Notice of Project Change

Project Name: Crop Circle Cranberry		EOEA #: 14221	
Street: 0 Ring Road			
Municipality: Plympton/Kingston		Watershed: South Coastal	
Universal Tranverse Mercator Coordinates:		Latitude: 41.58.37.78 N Longitude: 70.47.12.12 W	
Status of project construction: 0 %complete			
Proponent: Crop Circle Cranberry			
Street: 131 Ring Road			
Municipality: Kingston		State: MA	Zip Code: 02364
Name of Contact Person From Whom Copies of this NPC May Be Obtained: Michael E. Russell, P.E.			
Firm/Agency: Site Design Engineering, LLC		Street: 11 Cushman Street	
Municipality: Middleboro		State: MA	Zip Code: 02346
Phone: 508-967-0673	Fax: 508-967-0674	E-mail: mrussell@sitedesigneng.com

Modify 7.5+/- acre bog expansion to a 5.3+/- acre for the same area considered previously. WMA Withdrawl Permit for expansion reduced to approximately 49,467 gpd. (approx. 159,467 gpd total) Minimal buffer zone activity will occur for the activity.

BOG LAYOUT AND FLUME PLAN

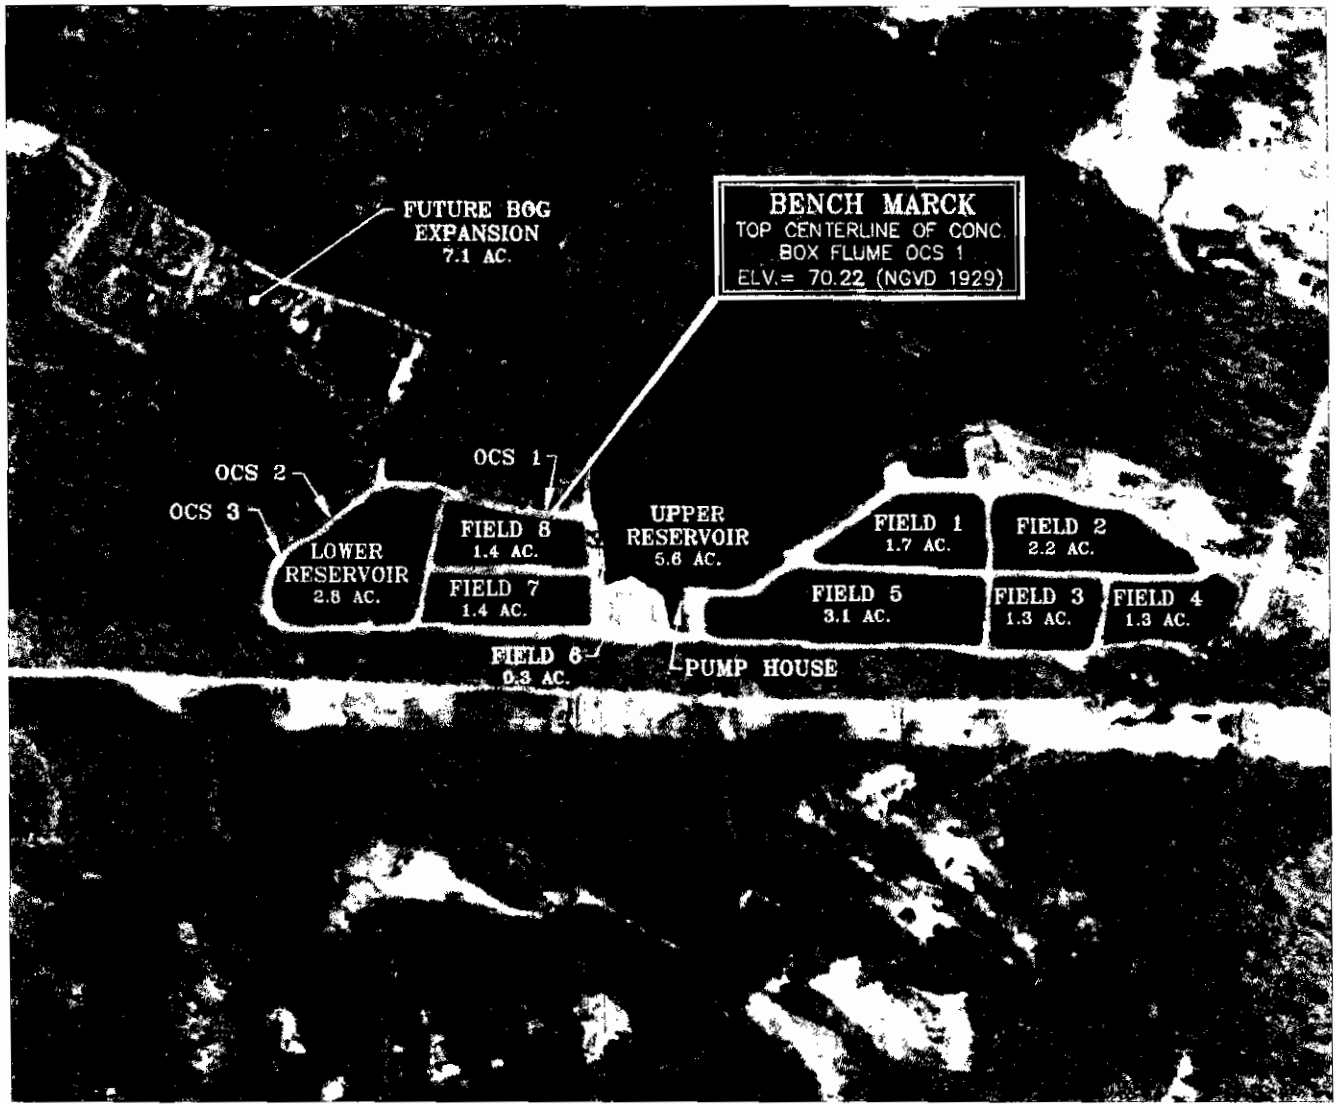
Project has been modified to reduce the bog expansion area to 5.3+/- acres and water withdrawal for the expansion area to 49,467+/- gpd from 70,000 gpd. The project modification also includes the addition of a by-pass flume from the upper reservoir to Barrows Brook. Previously the upper reservoir flowed directly into the lower reservoir. The lower reservoir discharged into Barrows Brook via two (2) flumes. Under this modification water supply to the expansion area will be served by the lower reservoir via a pump station and discharge line located within the limits of the existing access road between the two areas. (see Expansion Plan Locus). The purpose of the by-pass flume is to help balance the flow entering Barrows Brook and to regulate the flow during different conditions. (see attached USDA diagram for expansion area). The proponent has at the request of DEP and local environmental groups placed a flow gauge downstream of the bogs in Barrows Brook to monitor flow conditions throughout the year. The by-pass flume may help regulate flow as necessary. It is estimated from available data that the current storage in the upper reservoir is approximately 17.0+/- acre-feet. The approximate available storage is estimated to be 8.5+/- acre-feet which is based on an average top of reservoir elevation. The lower reservoir is approximately 20.0+/- acre-feet. The approximate available storage is estimated to be 4.0+/- acre-feet which is based on an average top of reservoir elevation. Monthly and annual projected water usage data for both the existing bog operation and the proposed expansion is described in the Farm Management Plan included with this document.

The expansion area has been reconfigured to abandon the previously proposed tail-water recovery area which required wetland alteration and replication. Additionally the reconfiguration locates the expansion area outside of the estimated wetland buffer zone as shown on the most recent MassGIS data layers.
